FINAL NOTES

Kootenai River Habitat Restoration Program Modeling Subgroup Meeting

May 18, 2016

Figure 4. Bonners Ferry Islands and Straight Reach construction phasing.

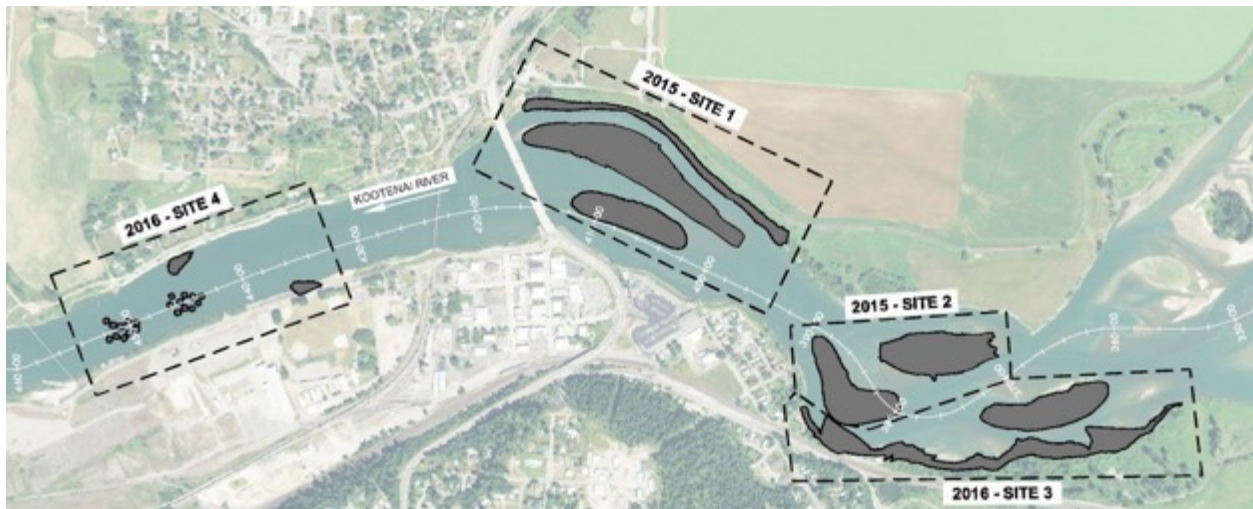
- Sean W. – How about turbidly?
 - Matt D. – The plume dissipated by the time it got to the railroad bridge. There were no complaints about turbidity.
- Zac C. – What were the final stable side slopes on the pools?

- Matt D. – The design was 5:1, that was based on results from previous designs. We used GPS on all equipment for building things. We got some wood out of excavation of the pools. We also did watering to keep the dust down and to keep materials from catching fire or getting too brittle.

- Matt D. – Pools are more challenging to build. The pools are about 2-4 feet shallower than the design on first pool. One interesting thing related to the pool construction, with the removal of a big volume of material I think we increased the local gradient upstream and think the bed of the river degraded and washed into the upstream end of the pool. Believe this was construction related. The lesson I learned here is that we didn't anticipate this and it is probably related to fact that this was built in phases. The work on the south bank where we have the structures wasn't built yet and we didn't model this interim condition scenario.

- Sean W. – What is the sediment character at the head of the pool?
 - Matt D. – It is coarse gravel. The material that went in is pretty loose.
 - Zac C. – what is the gradient out there?

- Matt D. – It changes.
 - Zac C. – It looks like what you have is an in river gravel mine.
 - Jon N. – How can you be sure that it is construction related? These were made 3-4 months after the pool was cut.

- Matt D. – It was happening while they were building the pool. They would call and say they were struggling with this end of the pool, that it was filling in overnight. What are you thinking?

- Jon N. – It's just hard to say that its only due to that. Those lower flows are when you get things to move. I'm not saying anything either way – just questioning how you can say with such confidence that its only construction related. The model results suggest things do move there.

- Matt D. – I'm skeptical about that. It's just clear water there, I don't see a lot of sediment there.
 - Jon N. – I'm just cautioning and saying we should get another survey.

- Sean W. – You could stick a GoPro on the excavator.
 - Jon N. – The bed load is moving at low flows.
 - Matt D. – We should look at whether the bed has degraded.

- Rich M. – It hasn't. There's a cross survey upstream from there. I think there's no elevation change upstream.
- Duncan – In the past you had a place on your web site where old presentations and notes were posted. I'd like to be able to go back and look at those again.
